RENESAS TECHNICAL NEWS

No.M16C-112-0309

M30245MC/8-XXXGP

Cautions on Serial I/O

Operation when UiBRG is set to '00h'

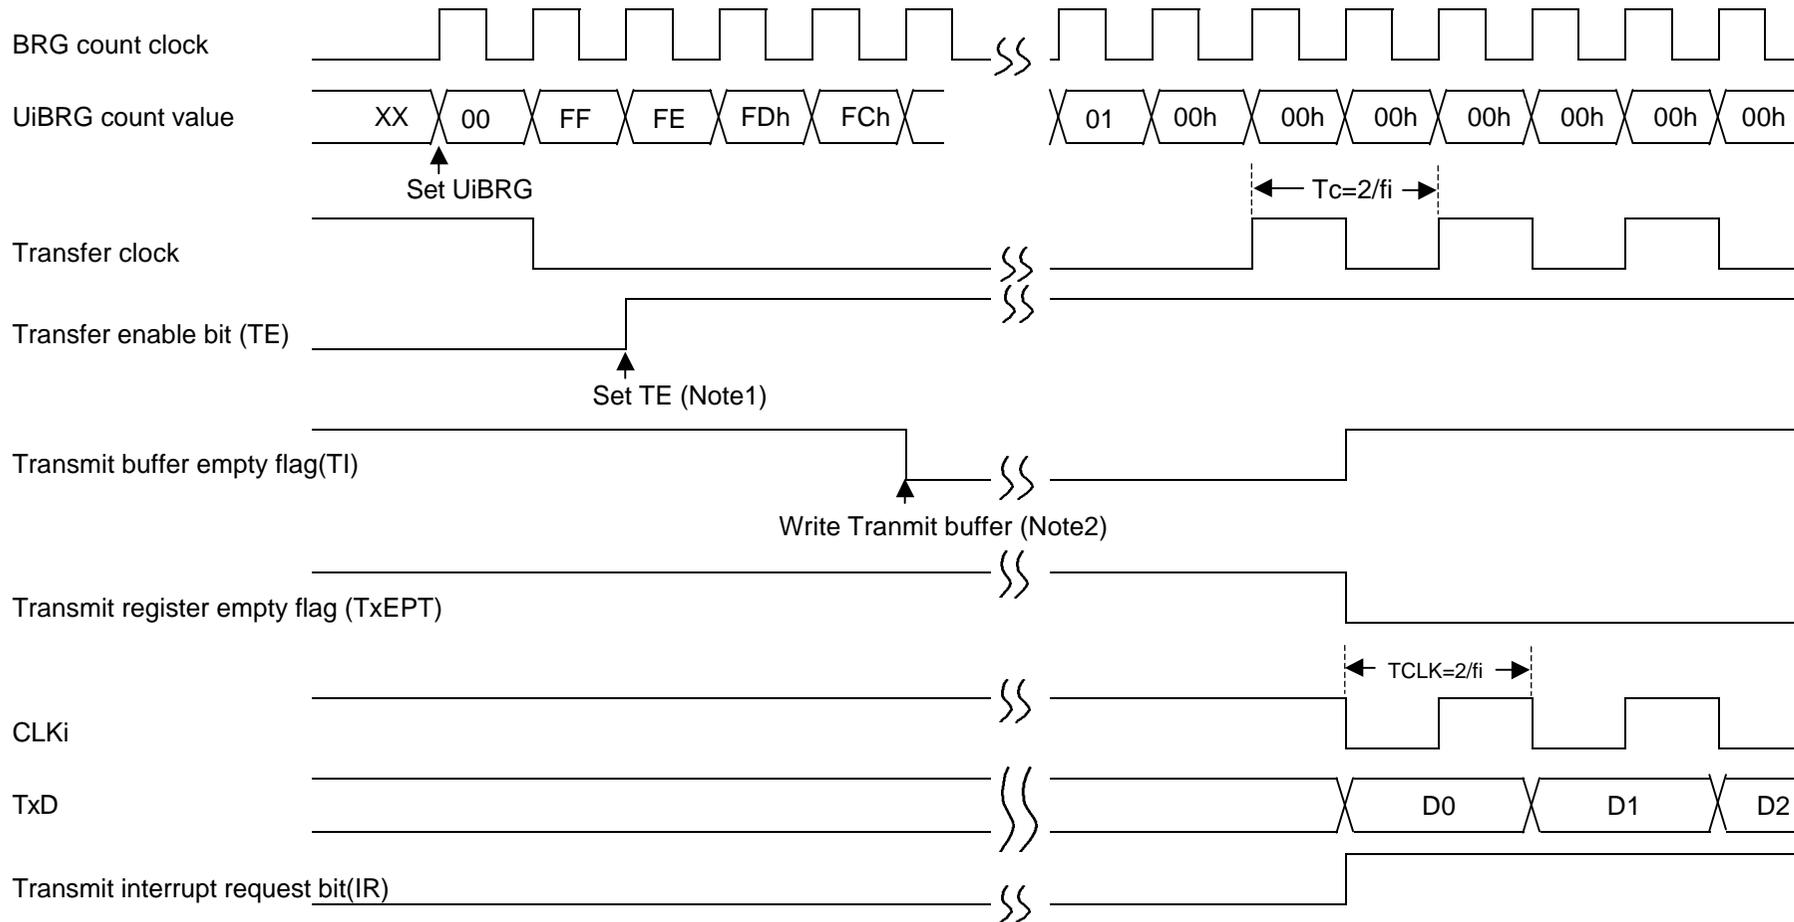
Under the condition below, there is a possibility that the cycle when the first data transfer is available is delayed for 256 cycles (maximum) of BRG count source.

- UiBRG= 00h (no division)
- Clock synchronous serial I/O mode (internal clock or external clock)
- UART mode (internal clock)

Due to the delay of the cycle when the first data transfer is available, Transmit register empty flag (TXEPT) is delayed as well. Please consider the delay when judging TXEPT to know the status of the transfer.

BRGi divides the count source by n+1 (n: value set to UiBRG). The divide-by-two signal of the underflow signal is UARTi Transfer clock or UARTi Receive clock. In case that UiBRG is set to '00h', there is a possibility that the first underflow of BRG is delayed for 256 cycles. Therefore, data transfer is not available until the first underflow is generated. Underflows except the first time are generated during the expected cycle (no division). The timing diagram in the next page shows an example of the behavior.

- (1) In order to eliminate the influence of the delay of the cycle when the first data transfer is available, please set Transmit enable bit (TE) and/or Receive bit (RE) 256 cycles (of BRG count source) after setting UiBRG. Since underflows except the first time are generated during the expected cycle, the delay of the first underflow of BRG does not affect the cycle when data transfer is available.
- (2) If case (1) above is impossible, please set UiBRG to any value except '00h'. The delay of the first underflow of BRG will not occur.

M30245MC/8-XXXGP will be revised. The new revision of the chip will be available for ROM ordering in Nov. 2003. If case (1) or (2) above is implemented, two revisions of the chip behaves in the same way.
